MODEL:	TYPE:	SECTION/GROUP:	DATE:
<b>D Coaches</b>	<b>Field Change Program</b>	<b>08- Engine</b>

Ref. MCI NHTSA Recall No.: 18V-309

Ref. MCI Transport Canada Recall No.: 2018-256

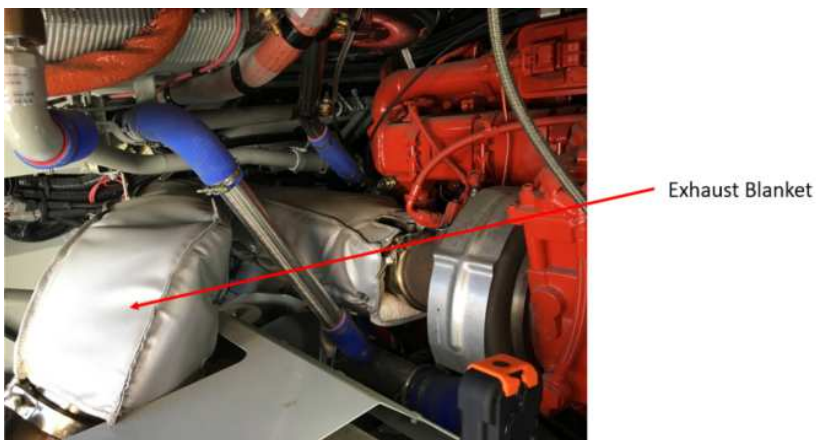
Locate and remove the two exhaust pipe clamps and the support bracket fastener. Remove the exhaust pipe from the vehicle.

### 4.3.1 Installing the New Exhaust Pipe

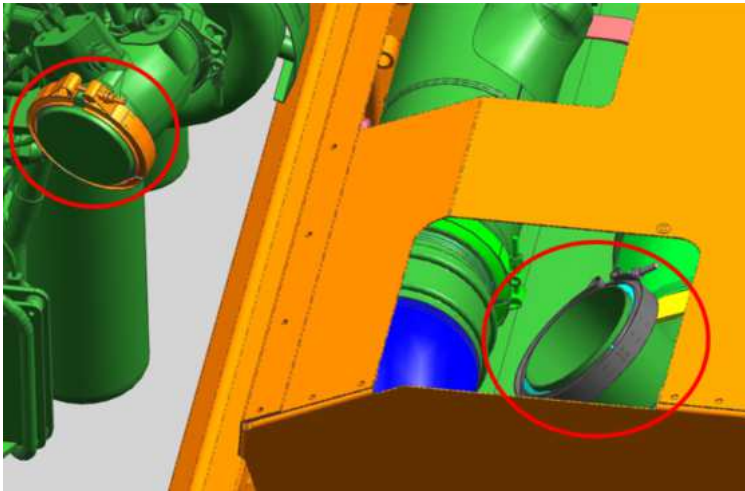
Place the new gaskets and clamps on the turbo flange and the aftertreatment flange.

- Place the new exhaust pipe between the turbo and the aftertreatment assembly.
- Torque the V-band clamps per the torque table below.
- Torque the support bracket fastener per the torque table below.
